HISTORIC PRESERVATION BOARD DESIGN REVIEW COMMITTEE STAFF REPORT October 24, 2019

| Project # | HPB19-192 |
| Project Type | Minor Exterior Alteration |
| Property Address; Historic Name | 417 Frank Lloyd Wright Way; The "Columbus W. Deen" House |

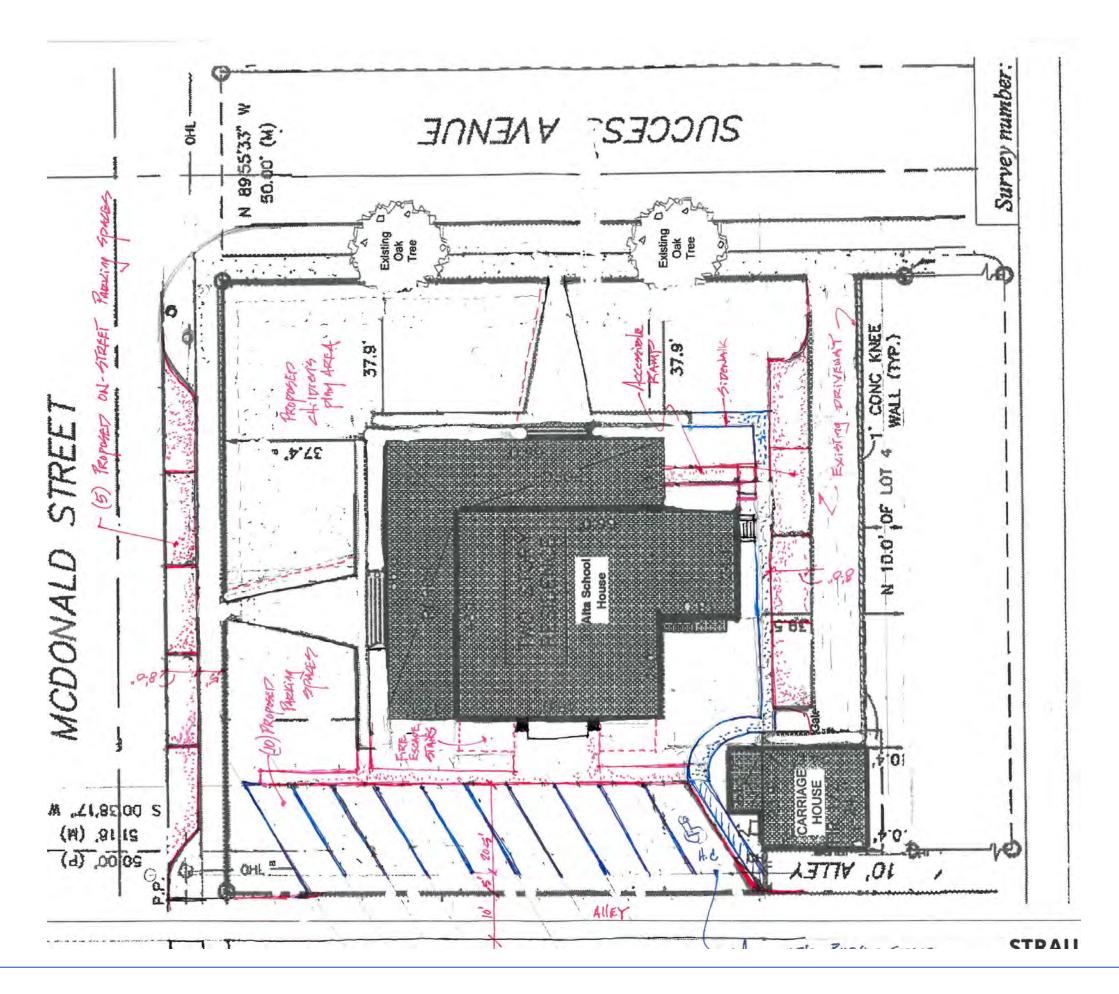
In evaluating the request for building alterations, staff finds the request to remove four casement windows, architectural banding, and brickwork from the second-story, west elevation wall to install doorways for fire escape stairs is inconsistent with the Standards and Design Guidelines listed above, as it adversely affects the architectural integrity of this landmark building. Banks of horizontally-oriented casement windows in consistent opening sizes are a character-defining feature of the Prairie style, as is the brick banding beneath the windows. The request proposes to remove historic materials and interrupt the horizontal rhythm of these character-defining window openings and banding on a highly visible wall, as well as introduce intrusive doorways and stairs. This alteration is also unlikely to be reversed in the future.

- The request to add ten parking spaces to the west yard of the property is inconsistent with the applicable Standards, as this parking lot diminishes the historical setting of the property. The original setting is a component of a property's historic integrity, and is important to maintain for properties as significant as the Deen House. While the Design Guidelines contemplates vehicular access for single-family residences from alleys to detached garages, carports, or parking pads in rear yards, this guidance is not contextually appropriate for a commercial parking lot.

- The request to add four parking spaces adjacent to the existing driveway does not detract from the historical setting and context of the property, as these spaces are located at the rear of the property and the original driveway width is maintained at the entrance from Success Avenue.

Staff recommends denial of the request for conversion of the second-story, west elevation casement windows to doors, addition of fire escape stairs, and the addition of a parking lot consisting of ten spaces in the western yard off the alley.
